**MEMO to Planning Commission**

**Amended Staff Report Dated August 8, 2023  
DR-21-23**

Chase Bank

Type III Site Design Review (DR-21-23)

MODEL  
DRAWING STANDARDS v20.5  
SHEET TITLE  
CIVIL AND DIMENSIONAL CONTROL PLAN  
SHEET NUMBER

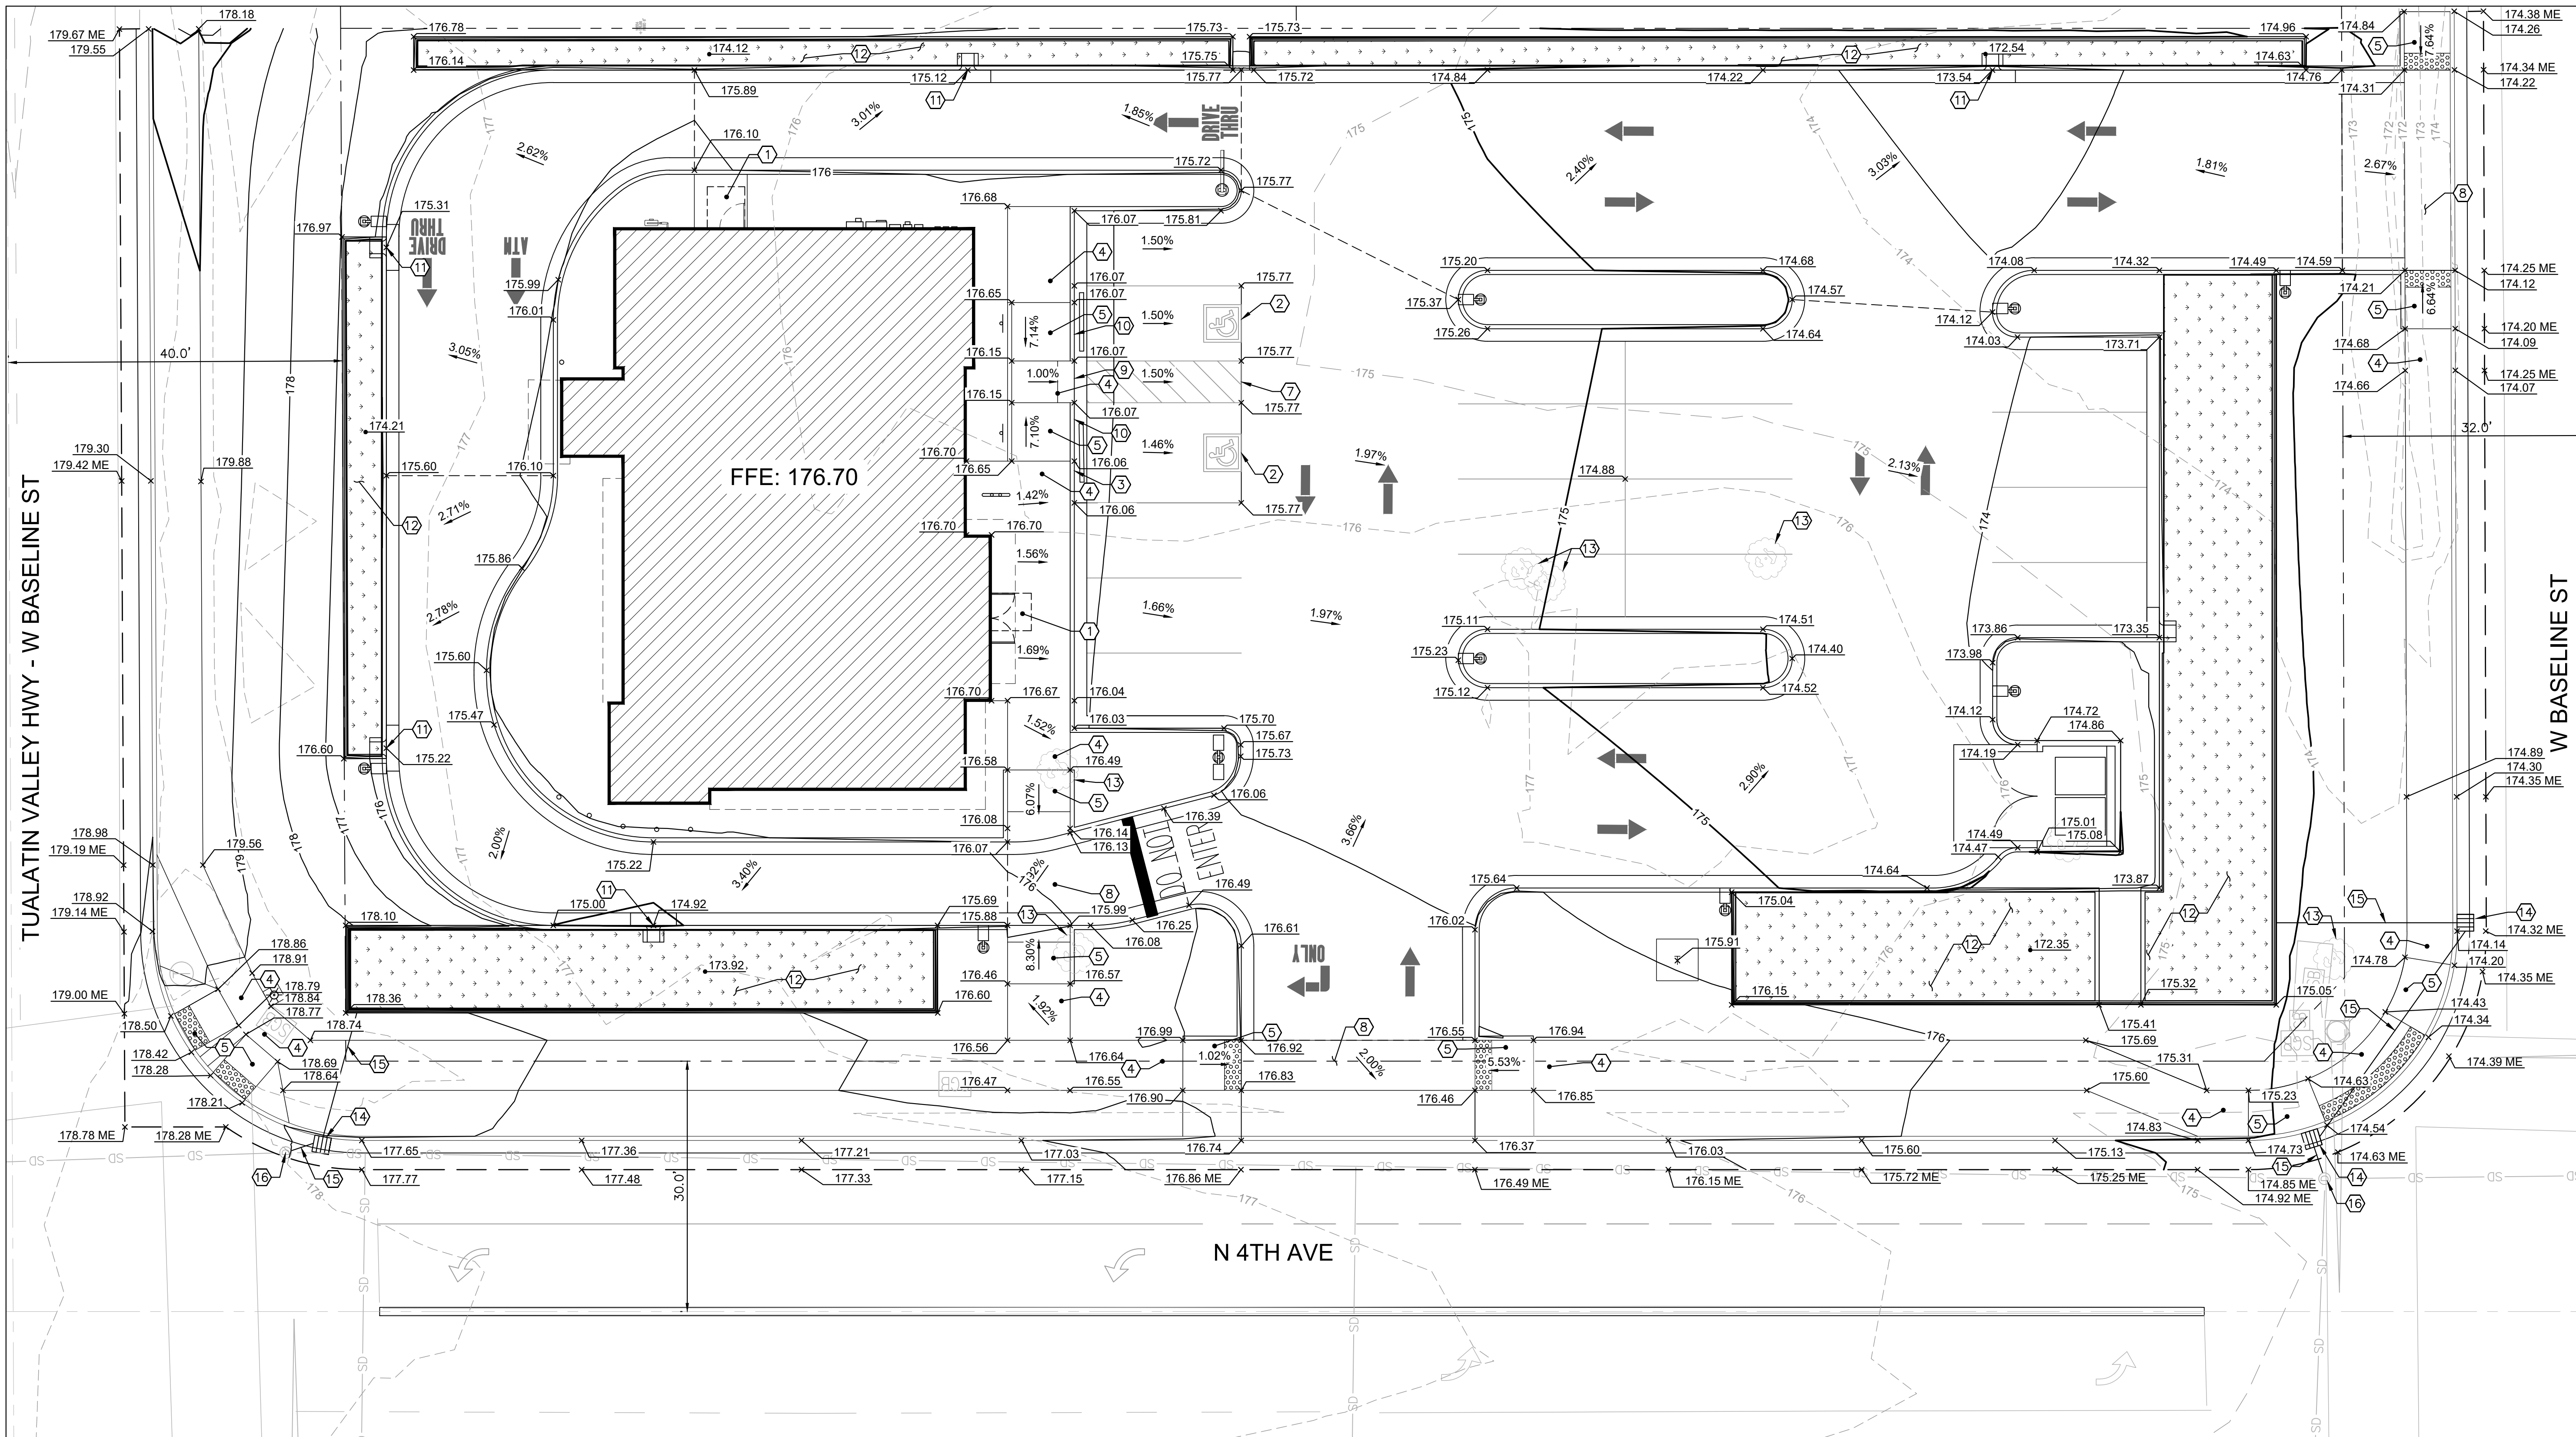
Can you please take a look at Sheet C3.00, note/detail #11 and the Site Information column. It describes that two bicycle racks will be provided. One will be near the front door and the other will be at the drive-thru height bar. The height bar/bicycle rack appears to be in landscaped area. Wondering if this is a mistake on the sheet? Can you please verify if you intend on installing one or two bicycle racks. The one by the front door makes sense, but the other one does not.

application that 3 bicycle parking spaces will be provided. The detail of the proposed bicycle rack is a ‘hooped’ rack, which accommodates 5 secured bicycles. Sheet C3.00, detail note #11 shows the location of two racks. One will be near the front door and the other will be at the ‘height bar’ of the drive-thru ATM lane. Staff clarified with the applicant that only one bike rack will be located on the site, near the front door, which has been included within Exhibit “A” and “E”. The detail of the bicycle rack shows that 5 bikes can be attached to it. Therefore, the minimum required 4 on-site bicycle parking spaces can be accommodated with 1 bicycle rack. The bicycle rack shall be installed near the front door, prior to final occupancy. This shall be a condition of approval.
